INSTRUCTION TO SERVICE

ITS: 5124	
SECTION:	549 HVAC
WRITTEN BY:	Kevin Robinson
SUBJECT:	Remove and replace copper lines at the booster pump

**Complete this ITS for SR1507, SR1559, SR1575 and
SR1576 ONLY.**

Figure 1 – Clamp Plates (Aux heater and engine removed for clarity)

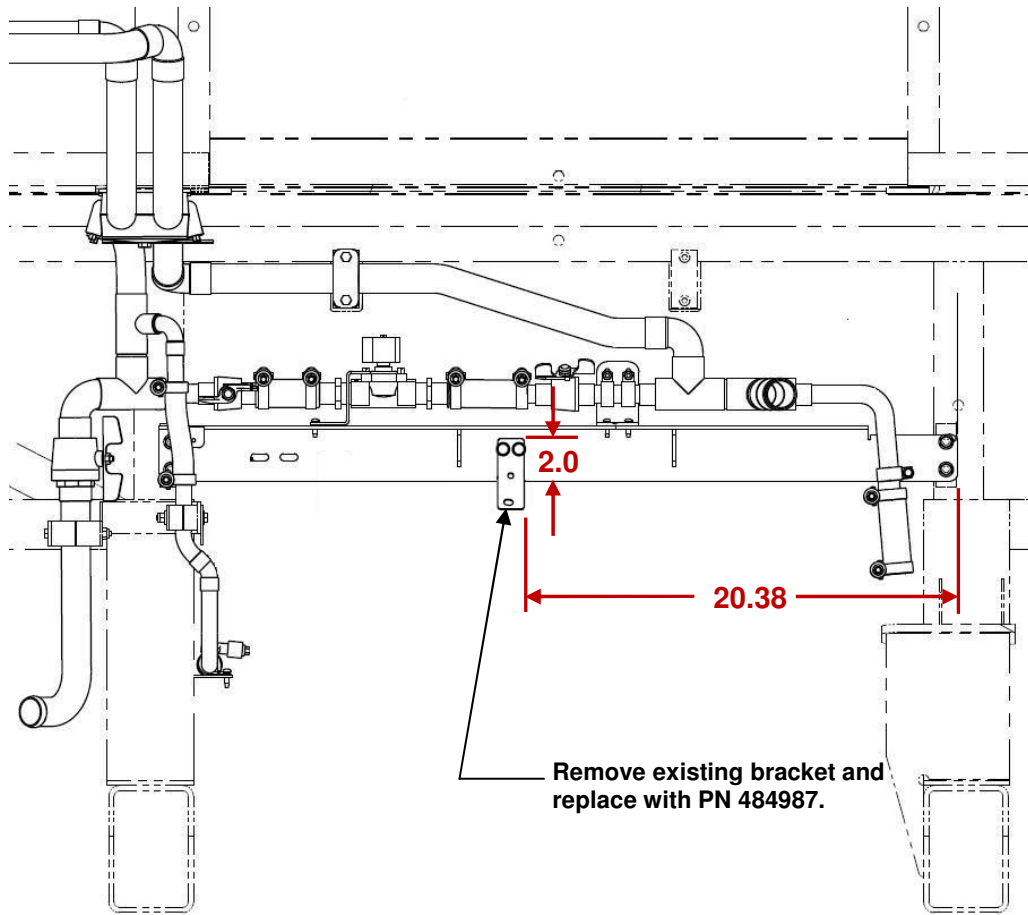
8. Place the supplied clamp support bracket (NF PN 484987) in the location shown in Figure 1 and secure it in place with two 1/4 inch self tapping screws.(NF PN 34S04012) and two flat washers (NF PN 10W04000).

Figure 2: Clamp Plate Swap Out

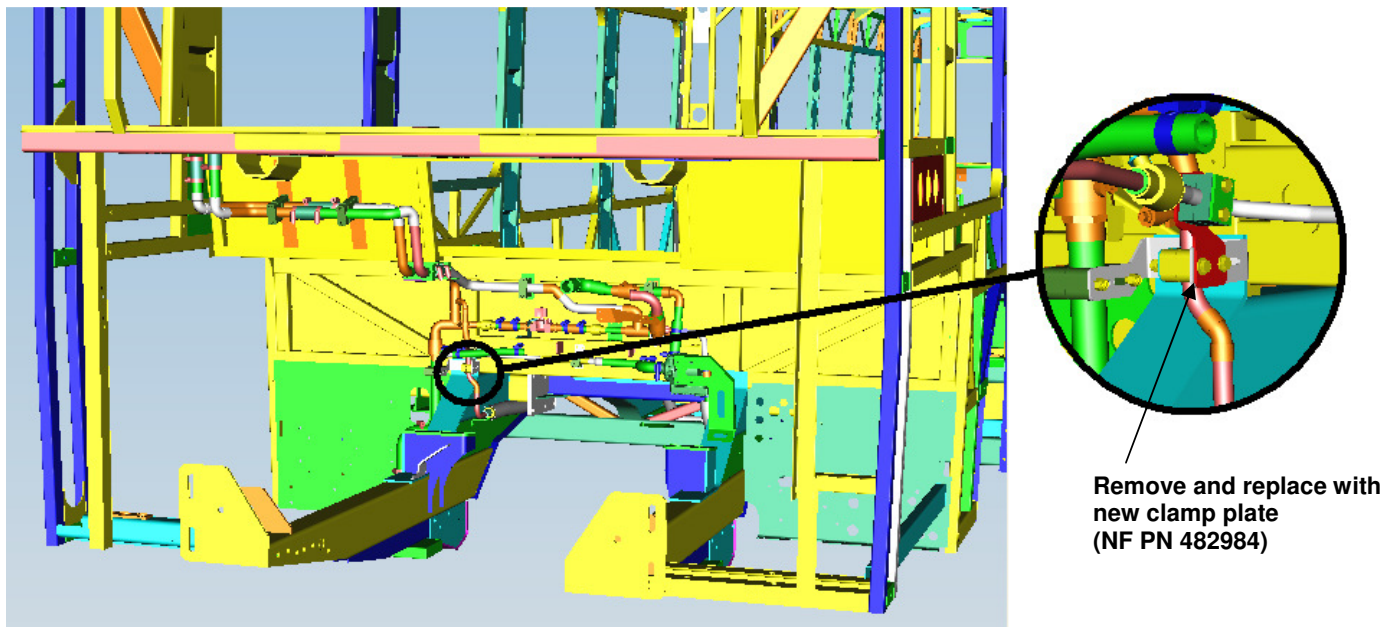
9. Remove the clamp plate from the tube clamp that supports the vertical tube from the under floor heater lines on the street side of the bus and replace it with the new supplied clamp plate (NF PN 482984). Secure the new plate with the hardware removed from the old one but replace the two nuts with new ones (NF PN 40N04000).
